DS90LV047ATMTCを用いたSub-LVDS信号レベル変換動作について

Sub-LVDS signal level conversion operation using DS90LV047ATMTC

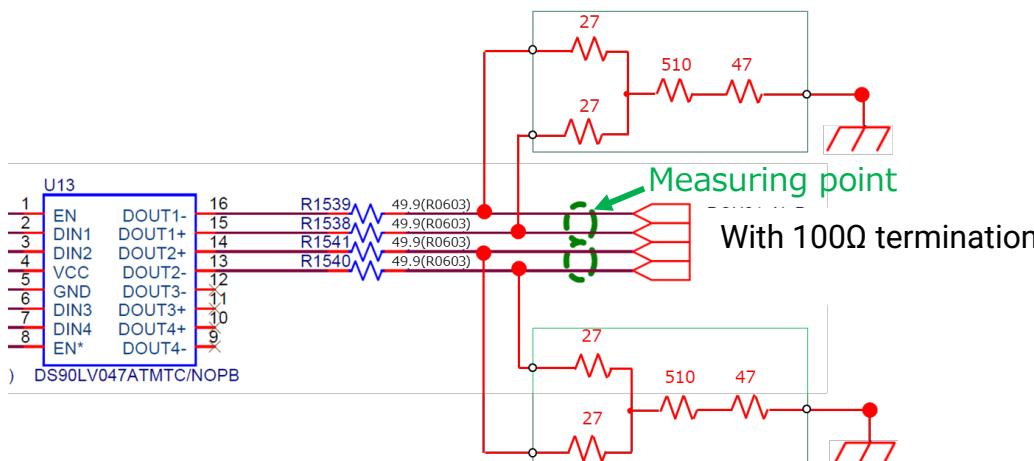
As shown in the figure below, when connecting a resistance for Sub-LVDS level conversion to the output of the DS90LV047ATMTC and measuring the amplitude level, At the DC level (input open), we were able to obtain the expected common voltage/differential signal. (See table below)

Next, when I applied a clock (84.7MHz) signal to the input (DINx), the differential voltage was out of specification.

It has been confirmed that the amplitude of the differential voltage decreases when the input frequency is increased to 100MHz/200MHz.

Also, the DS90LV001TM has the same phenomenon.

(1) Is there any problem in operating the target IC with a resistor for level conversion?

(2) Does the amplitude of the output waveform change depending on the input frequency?

(3) Is there a minimum frequency specification for the input signal (DINx) of the DS90LV047ATMTC and DS90LV001TM?
